# HOMOLOGATION AND TECHNICAL SPECIFICATION UPDATE BULLETIN

HOMOLOGATION	Rotax 125 Mini Max	HOMOLOGATION NO.	111H
BULLETIN NO.	Rotax 17 MiniMax	BULLETIN DATE	9 December 2016
SUBJECT	Support Plate System for Mini Max Ignition Coil

Support Plate System for Rotax 125 Mini MAX

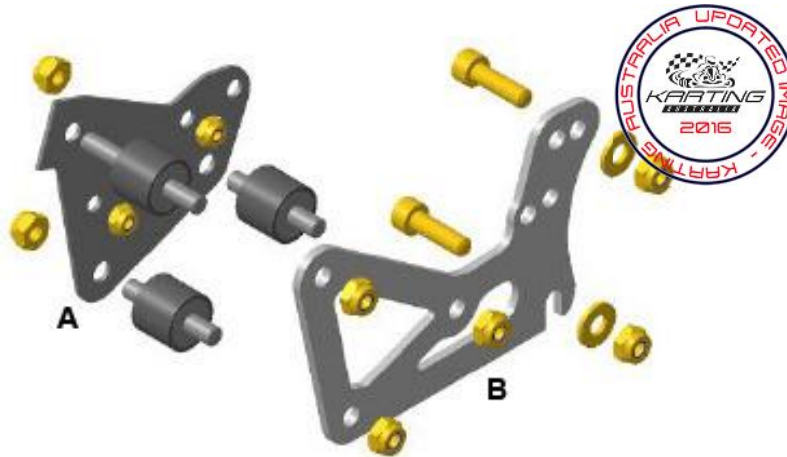
The new support plate system for mounting the ignition coil and magnet valve is a more compact system with less electrical connections at the backside of the engine, and the ECU now located in the battery housing. This system creates less risk of interference from any chassis components.

(A) Mounting Plate (Part No. 651 925)

(B) Retaining Plate (Part No. 651 935)
